SUBJECT: Comments on Draft Regulatory Guide DG-1144 and Draft
NUREG/CR-6909

Comments on Draft Regulatory Guide DG-1144 and
Draft NUREG/CR-6909

Figure 1. Issue of Transient Linking

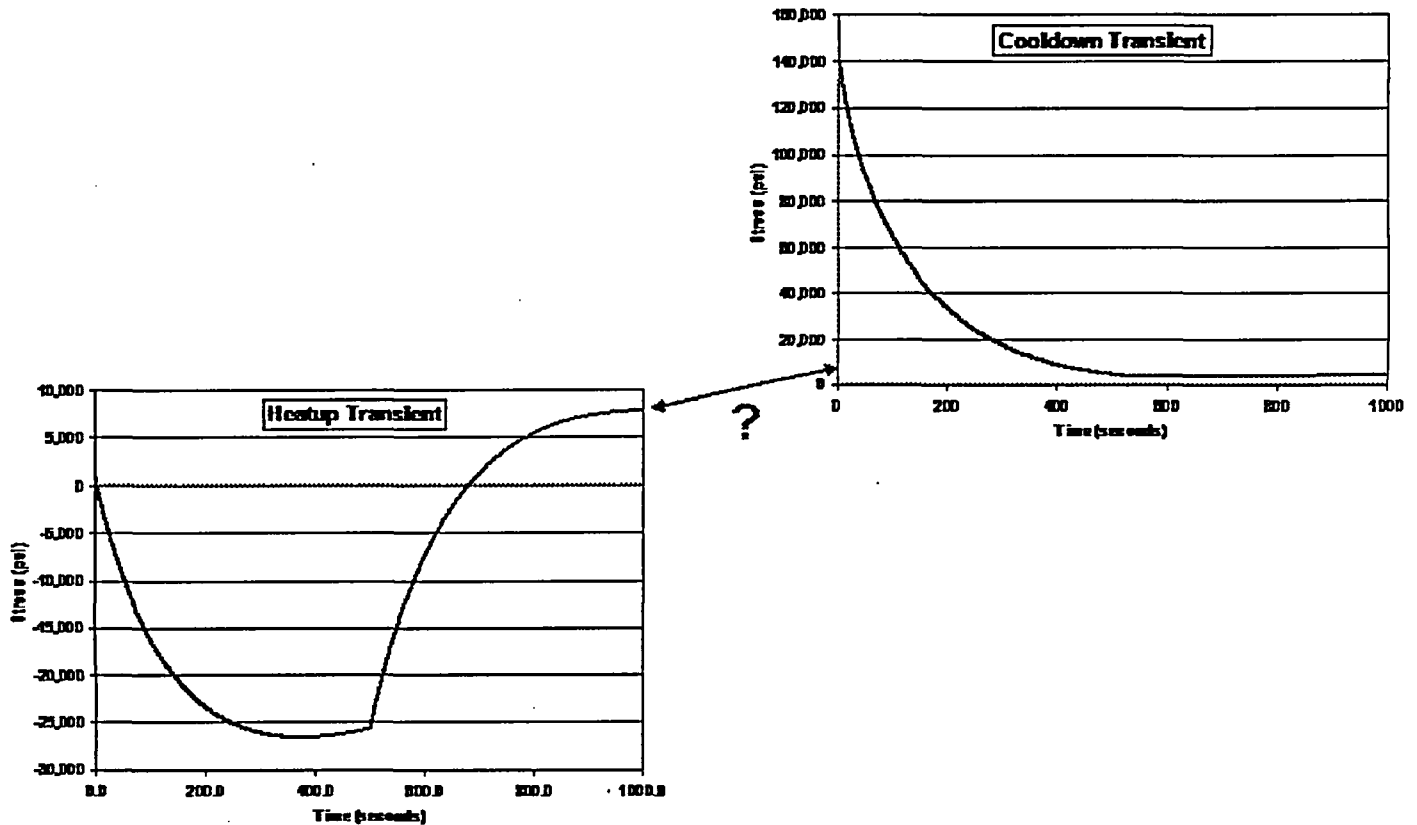
- a. "Linking" of transients pairs is not straight-forward and can lead to significant differences in results (refer to Figure 1) in part due to the following items:
- Treatment of cases where the starting and ending stress points are not equal needs to be clarified
 - The rate of change assumed for the discontinuity between transients needs to be addressed?
 - What is strain rate?

Recommended change – Clarify that the recommendations made in Section 4.2.2 of MRP-47, Rev. 1 for addressing linking of transients are an acceptable approach.
